FORM C-108 Technical Review Summary [Prepared by reviewer and included with application; V17]

From: Goetze, Phillip, EMNRD
To: Khem Suthiwan
Cc: Rose-Coss, Dylan, EMNRD; Schaefer, Alana, EMNRD; Gebremichael, Million, EMNRD; Powell, Brandon, EMNRD
Subject: Review of the C-108 Application for the Warner Caldwell No. 1A
Date: Wednesday, September 21, 2022 10:37:00 AM
Attachments: image003.png
 image005.png
 image010.png

RE: Warner Caldwell No. 1A

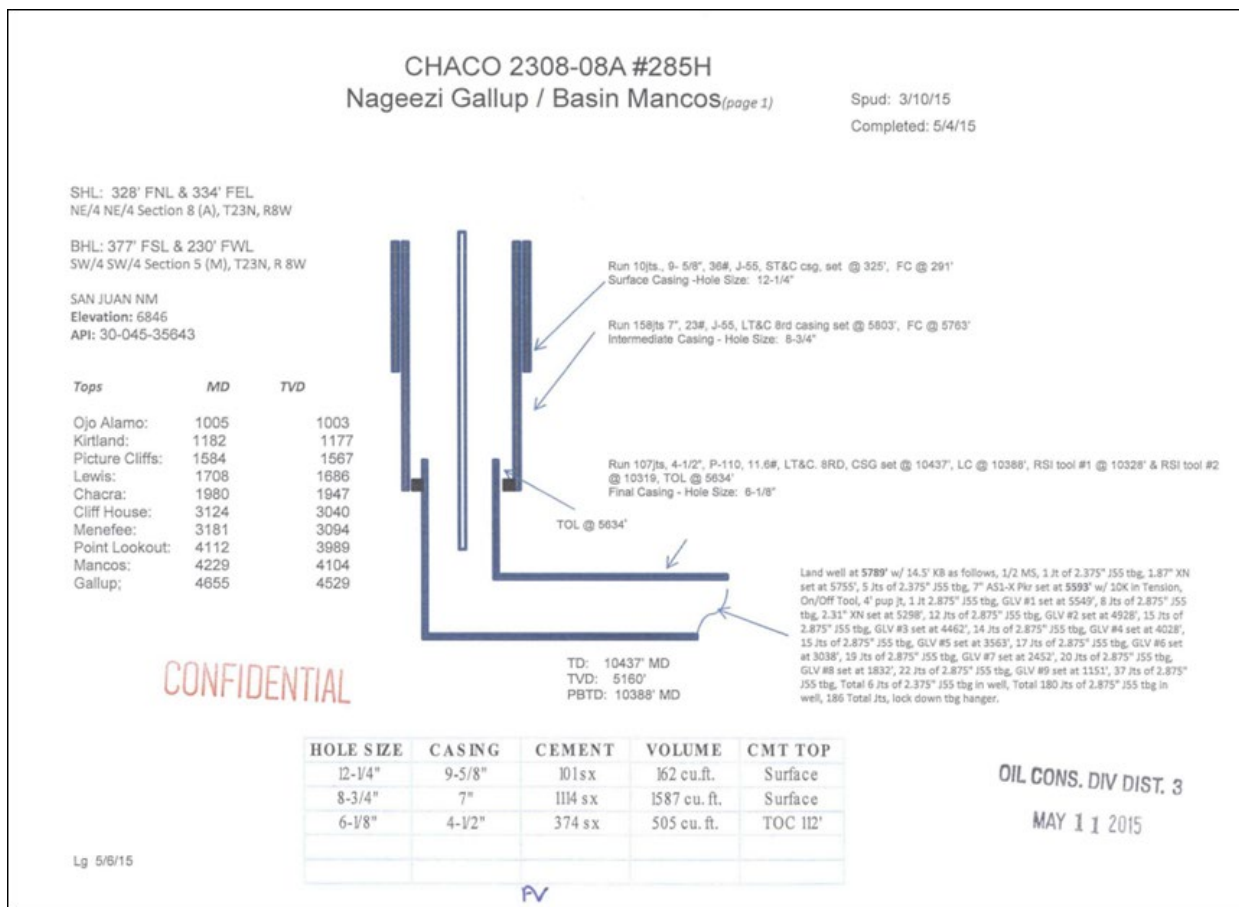
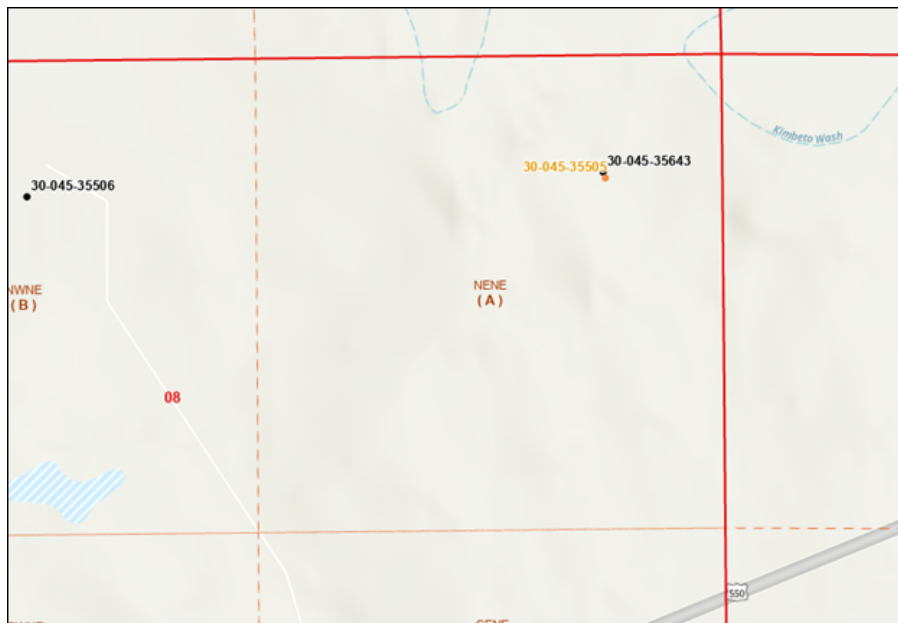
With regards to the Caldwell 1A application, the location of the proposed injection well was within 20 feet of a horizontal well (surface location) while my review of the application identified a second, shallow boring within 20 feet of the Caldwell 1A.

As to the abandoned boring, evidently the first attempt to drill the Caldwell 1A was not in the permitted location and required the boring for the surface casing to be plugged.

Though the boring did not penetrate the proposed injection interval, the plugged borehole (12.25 inches in diameter) increases the requirement that the current surface casing for the A1 be well cemented. The proximity of the two drilling events can cause concern as the abandoned borehole can provide a conduit for surface releases that could follow a poorly cemented annulus (of the completed well) to the Ojo Alamo, an USDW.
